GARRETT PARK, SEC. 2 (1-06016)

**4605 OXFORD STREET
 PROPOSED LOTS 24 & 25,
 BLOCK 53
 GARRETT PARK
 NEIGHBORHOOD MAP
 (PRELIMINARY PLAN NO. 1-06016)**

RE: Preliminary Plan No. 1-06016
Garrett Park Section II

SUBJECT: Preliminary Plan 120060160 - Garrett Park, Section 2: 4605 Oxford Street

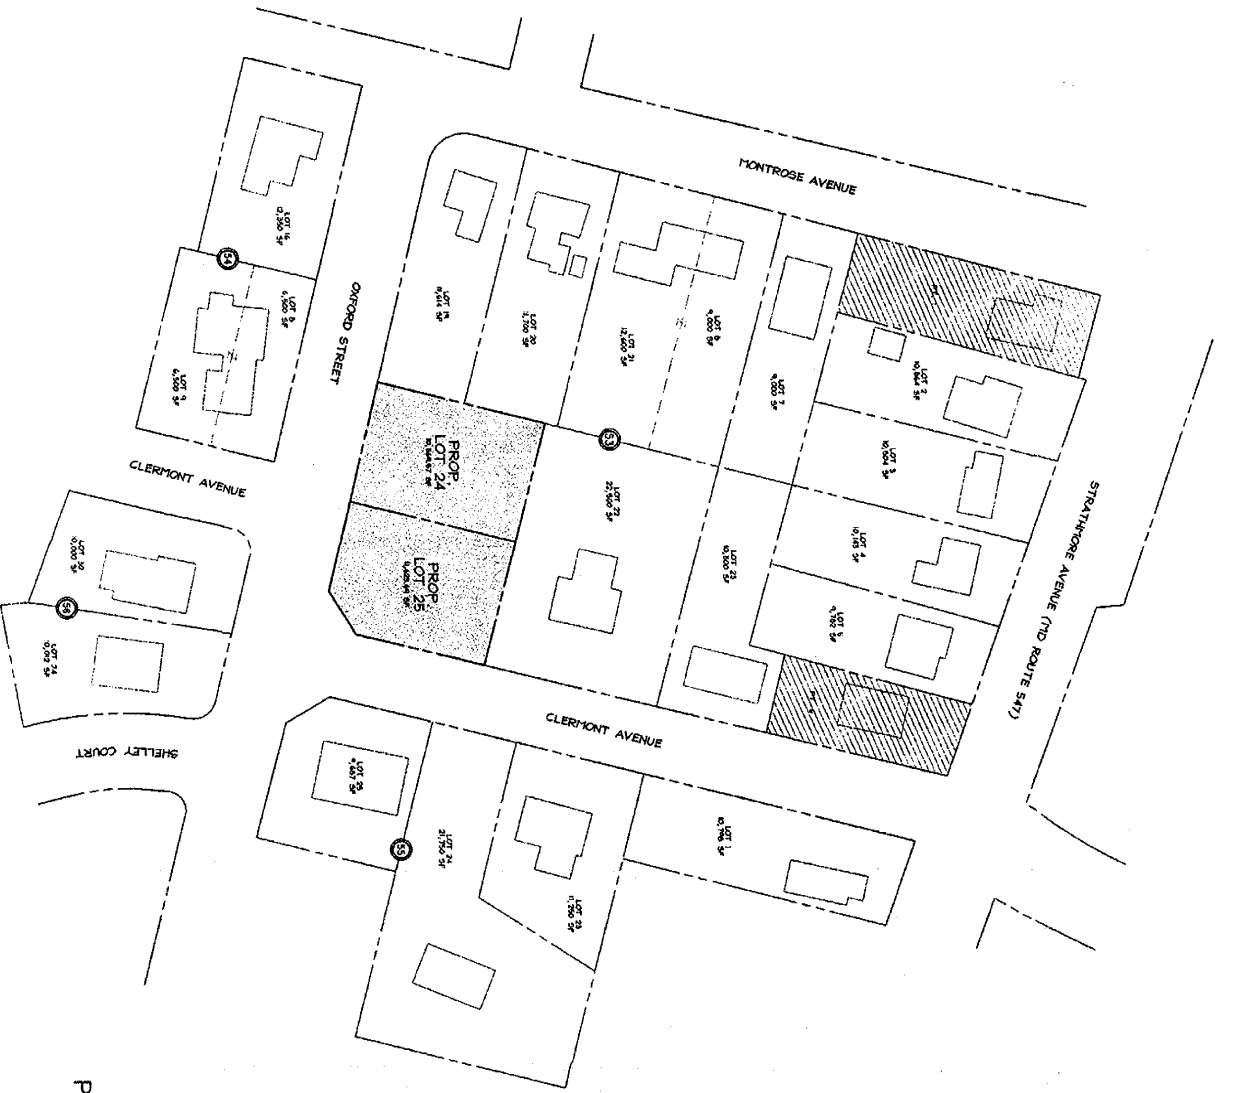
The line show on the proposed subdivision is not where my understanding of the property line between my home and the subject property is. I have spoken with CAS Engineering about this. The metes and bounds shown on their plat is not the same as the metes and bounds shown on a survey I have for my property. I am in the process of engaging a professional surveyor to obtain a second opinion. As you may be aware, there are a number of boundary issues in Garrett Park. When a large structure is proposed only 5 feet from my yard where I have just invested major time and money to improve my garden and patio area, a few feet can become very critical.

There is a large tree on public property that is not shown on the proposed plat plan. It happens to be right beside my property so I noticed it was not shown on the proposed plat plan. How many other "over sights" are there on this plan?

+ It will result in major drainage problems and does not preserve natural streams and drainage swales as required by the subdivision ordinance. There is already a drainage problem in this area because of the nature of the soils and the natural topography. I have been forced to invest over \$10,000 in correcting drainage problems on my property. The re-subdivision proposes to fill a major drainage swale on the property. I suspect it is the natural drainage swale for the surrounding area. When this is filled, where will the water go?? It will back up on my and other property owners' property.

+ There are a number of large and significant trees on this site. The subdivision as proposed would decimate these trees, leaving a barren site. This is inconsistent with the purpose of preserving trees as stated in the ordinance.

Because of the proposed grading-- right up to the property line, several large trees on my property would eventually be lost. Who is going to pay to have these trees taken down in several years after they die a slow death from root destruction from the grading?
